Evaluation of Physical Barriers – Downtown Perris Station

Address: 121 S C street St, Perris, CA 92570

Evaluation Date: 08-10-2021

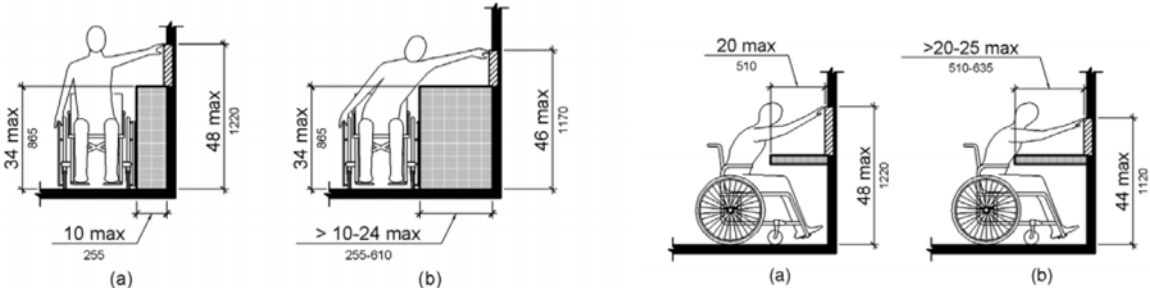
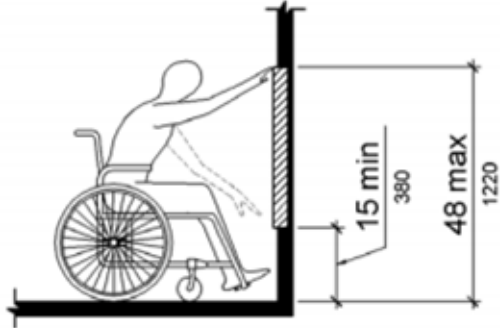
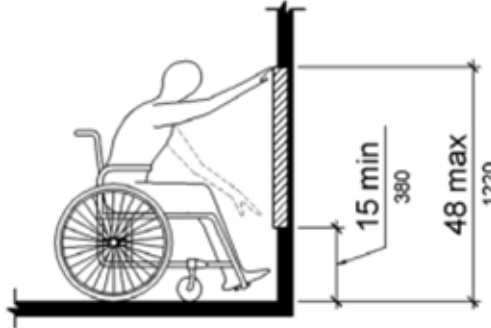
3. Accessible Routes		
a) Walking surface		
<p>i. Gaps and joints in concrete sidewalks on the accessible route are more than ¼” deep and ½” wide, and</p> 	<p>Examine accessible routes in entirety.</p> <p>Every joint deeper than ¼” and wider than ½” shall be filled.</p> <p>Every level change along the accessible route greater than ¼” and less than ½” height needs to be beveled (1:2) slope or repaired.</p> <p>Every level change greater than ½” needs to have a ramped surface (1:12) slope.</p>	 <p>Figure 302.3 Elongated Openings in Floor or Ground Surfaces</p>

Issues/Barriers Identified	Recommendations	Comments/ADA Requirements
<p>ii. Sealant/filler strips are missing.</p>  <p>Image at Pedestrian entry route from rear parking lot</p>		
<p>iii. Trip hazards on the accessible route</p>  <p>Image of change in level at main pedestrian entry (central)</p> <p>iv. At the DWS along the accessible route, open gaps create a trip hazard. Some DWS tiles have risen and create level changes.</p> 	<p>Eliminate all trip hazards at level changes higher than $\frac{1}{4}$"</p>	<div data-bbox="1526 828 1970 1030">  <p>Figure 303.2 Vertical Change in Level</p> </div> <div data-bbox="2293 828 2784 1090">  <p>Figure 303.3 Beveled Change in Level</p> </div>

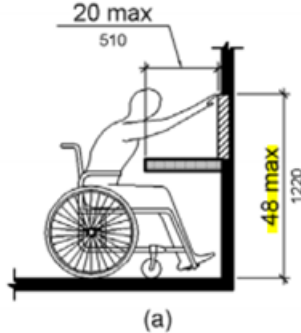
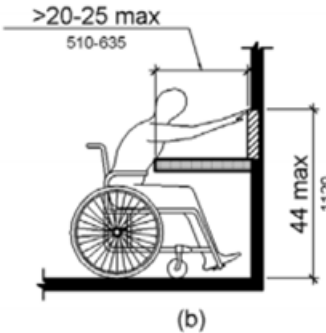
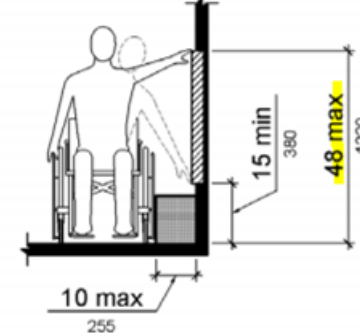
<p>ii. Clear space at gates on push side (North crossing- at all gates, South crossing- at one gate) is less than 48 inches.</p> <div></div>	<p>Clear space to be provided to allow ADA compliant access to gates when the arm is down.</p>	<div><p>(b) front approach, push side</p></div>
